PREPARATORY STUDY FOR THE REVIEW OF COMMISSION REGULATION 548/2014 ON ECODESIGN REQUIREMENTS FOR SMALL, MEDIUM AND LARGE POWER TRANSFORMERS

Final Report-Annexes

**Client: European Commission
Directorate-General for Internal Market, Industry,
Entrepreneurship and SMEs**

3rd July 2017

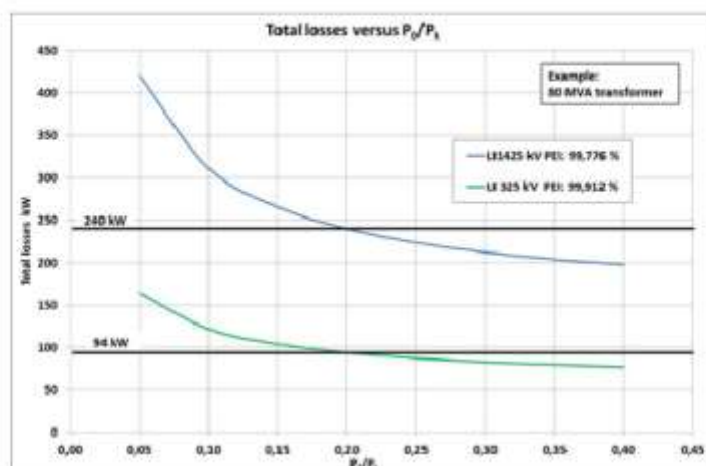
The above diagram illustrates the situation. The blue curve indicates how the total losses vary with different values of the fraction P_0/P_k when PEI = 99,776 %. The green curve indicates how the total losses vary with different values of the fraction P_0/P_k when PEI = 99,912 %. In the area between the blue and the green curve four more similar curves can be inserted for the voltage levels LI450-550, LI650, LI750 and LI950.

The upper black horizontal line indicates the total losses of 240 kW taken from the table in slide 22 with LI 1425. (The 240 kW maximum permissible total losses is of course independent of the fraction P_o/P_k). The lower horizontal black line indicates the total losses 94 kW, also taken from the table in slide 22, with LI 325. It can be noted that the blue curve crosses the upper black horizontal line at $P_o/P_k = 0,2$. The green curve crosses the lower black horizontal line also at $P_o/P_k = 0,2$.

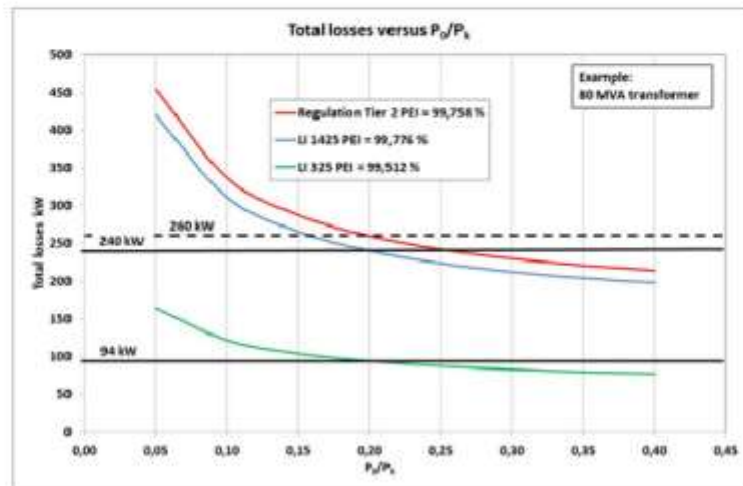
The next diagram is almost the same as the foregoing diagram. The only difference is that in this second diagram, a red curve is inserted, representing PEI = 99,758 % as given in Tier 2 of the Regulation for a 80 MVA transformer.

It appears from the diagram that the PEI-value given for Tier 2 in the Regulation allows higher total losses than indicated by the blue and especially by the green curve.
